ADDRESS . . : *UNASSIGNED SUBDIV:
CONTRACTOR : PHONE :
OWNER . . . : LUTHERAN OUTDOOR MINISTRIES PHONE :
PARCEL . . . : 05-0614- - -9004- - -
APPL NUMBER: 08-50019495 CP NEW CHURCHES & OTHER RELIGIOUS

STRUCTURE: 000 000 35X49 CABIN AND MEETING ROOM
FLOOD ZONE : FLOOD ZONE X

PERMIT: CBCO 00 CP BUILDING COMMERCIAL

To: Harnett County Inspections	From: Paul Briggs
Fax: 910-814-8277	Pages: 1 inc. cover
Phone:	Date: March 31, 2008
Re: Agape Camp Duplex Cabin	CC:

(SITE0305-Church Cabin -- 1369 Tyler Dewar Ln., Fuquay - CJ-7 3'4"15 Jack)

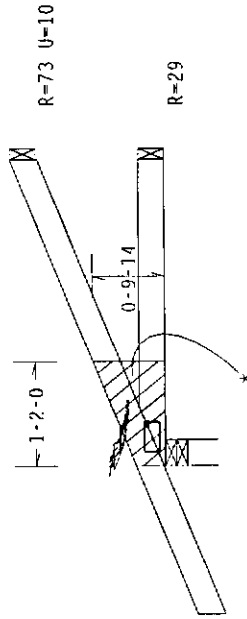
Truss repaired to mend cracked top chord.

Shore Truss and any supported spans in proper position as repair is being made.

* Two-1/2" (Nom.) X (See drawing for dimensions as shown) APA 32/16 rated sheathing (plywood or OSB) gussets (cut to fit). Attach one gusset to each face of truss with (1) row of 6d common (0.113"x2.0") nails @ 2" o.c. throughout all members without splitting lumber.
